Title of Change:	Assembly and Test Transfer from AUK Dalian, China to JCET CHUZHOU, China for TO92 Products, Case Outline Change from 29-11 to 29-10 for TLV431 and NCP431 TO92 Products.	
Proposed First Ship date:	23 Jul 2021 or earlier if approved by customer	
Contact Information:	Contact your local ON Semiconductor Sales Office or Marquita.Jones@onsemi.com	
PCN Samples Contact:	Contact your local ON Semiconductor Sales Office or < PCN.samples@onsemi.com >. Sample requests are to be submitted no later than 30 days from the date of first notification, Initial PCN or Final PCN, for this change. Samples delivery timing will be subject to request date, sample quantity and special customer packing/label requirements.	
Additional Reliability Data:	Contact your local ON Semiconductor Sales Office or Lalan.Ortega@onsemi.com	
Type of Notification:	This is a Final Product/Process Change Notification (FPCN) sent to customers. FPCNs are issued 90 days prior to implementation of the change. ON Semiconductor will consider this change accepted, unless an inquiry is made in writing within 30 days of delivery of this notice. To do so, contact PCN.Support@onsemi.com

文書番号# : FPCN23449X

発行日: 15 Apr

Before Change

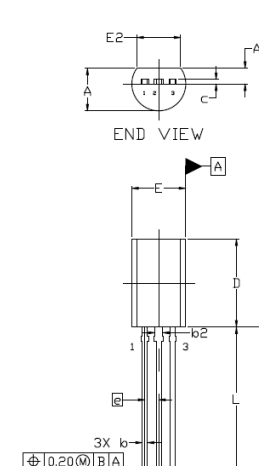
ON Semiconductor would also like to inform customers of the intent to change from case outline 29-11 to 29-10 for the TO92 products listed in this notification. The changes are listed below:

変更前:

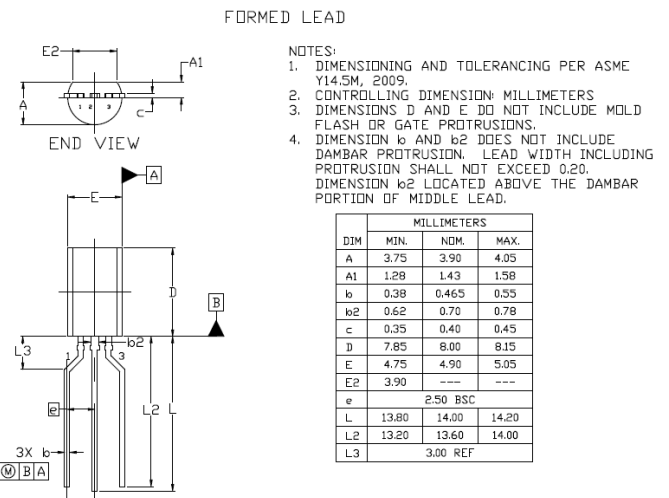
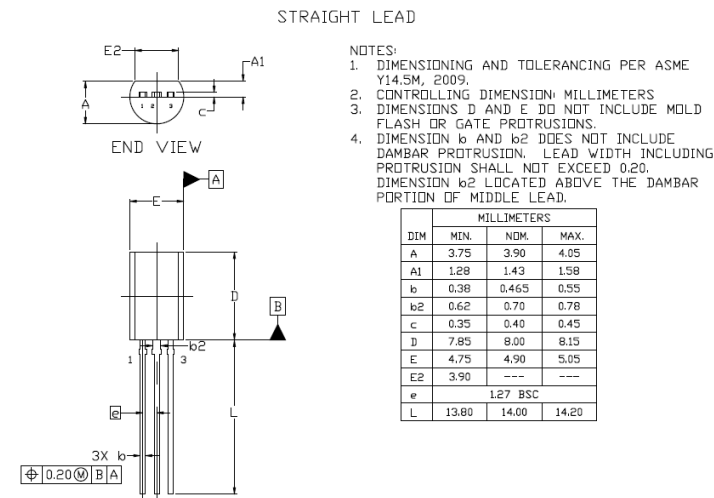
オン・セミコンダクターは、本通知に記載されている TO92 製品のケースアウトライン 29-11 を変更する意向があることもお客様にお知らせいたします。変更内容については以下をご覧ください。
